AMENDMENT NO. 1 DECEMBER 2020

**IS 1293 : 2019 PLUGS AND SOCKET-OUTLETS
FOR HOUSEHOLD AND SIMILAR PURPOSES
OF RATED VOLTAGE UP TO AND INCLUDING
250 V AND RATED CURRENT UP TO AND
INCLUDING 16A — SPECIFICATION**

(Fourth Revision)

FIG. 1C COMBINED SOCKET-OUTLETS'

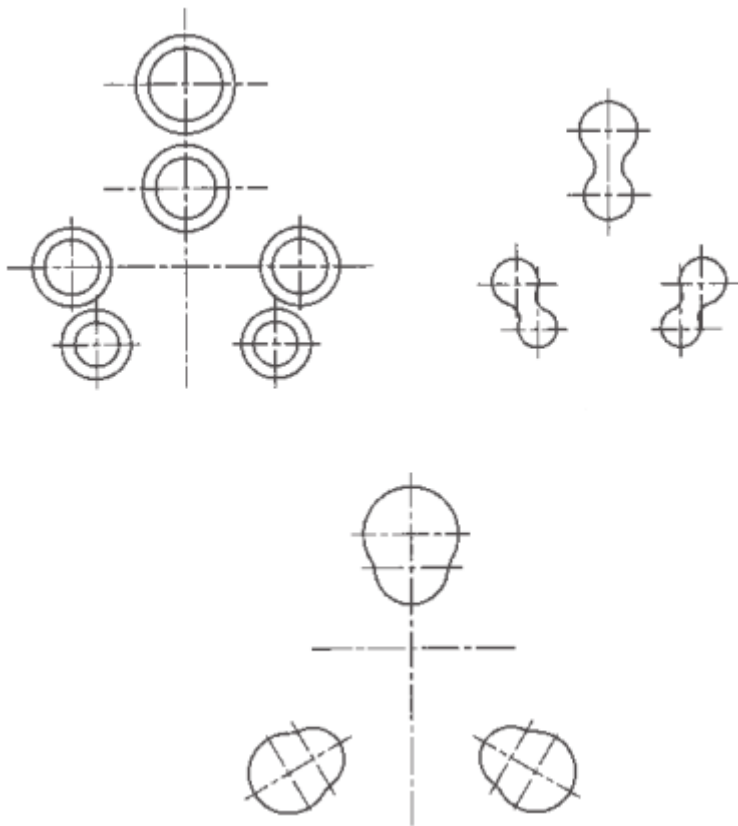
(Page 3, Fig. 1) — Substitute the following for the existing:

FIG. 4 SADDLE TERMINALS

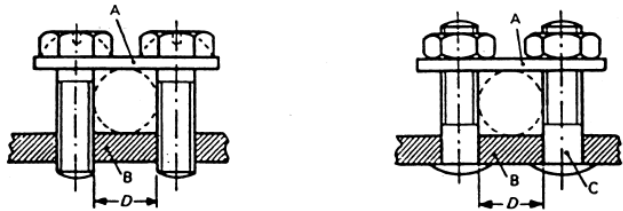
(Page 7, Fig. 4) — Substitute the following for the existing:

- Key
- A = Saddle
 - B = Fixed part
 - C = Stud
 - D = Conductor Space

<i>Cross-section of Conductor Accepted by the Terminal (mm²)</i>	<i>Minimum Diameter D of Conductor Space (mm)</i>	<i>Torque Nm</i>
Up to 4	3.0	0.5
Up to 6	4.0	0.8
Up to 10	4.5	1.2

The shape of the conductor space may differ from that shown in the figure, provided that a circle with a diameter equal to the minimum value specified for *D* can be inscribed.

The shape of the upper and lower faces of the saddle made different to accommodate conductors of either small or large cross sectional areas by inverting the saddle.

FIG. 5 MANTLE TERMINALS

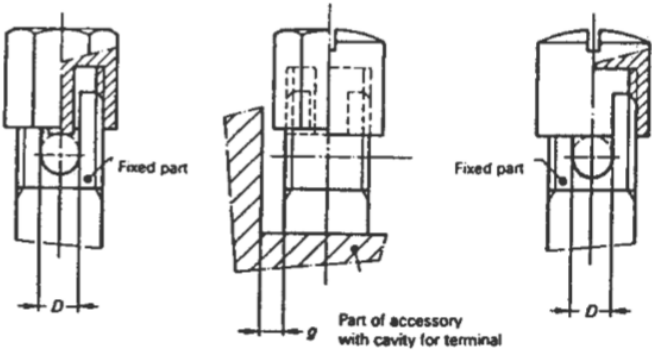
(Page 8, Fig. 5) — Substitute the following for the existing:

<i>Cross-Section of Conductor Accepted by the Terminal</i>	<i>Minimum Diameter D of Conductor Space ¹⁾</i>	<i>Minimum Distance g Between Fixed Part and End of Conductor When Fully Inserted</i>
(mm ²)	(mm)	(mm)
Up to 1.5	1.7	1.5
Up to 2.5	2.0	1.5
Up to 4	2.7	1.8
Up to 6	3.6	1.8
Up to 10	4.3	2.0
¹⁾ The bottom of the conductor space must be slightly rounded in order to obtain a reliable connection.

NOTE — The value of the torque to be applied is that specified in col 4 or col 5 of Table 1 as appropriate.
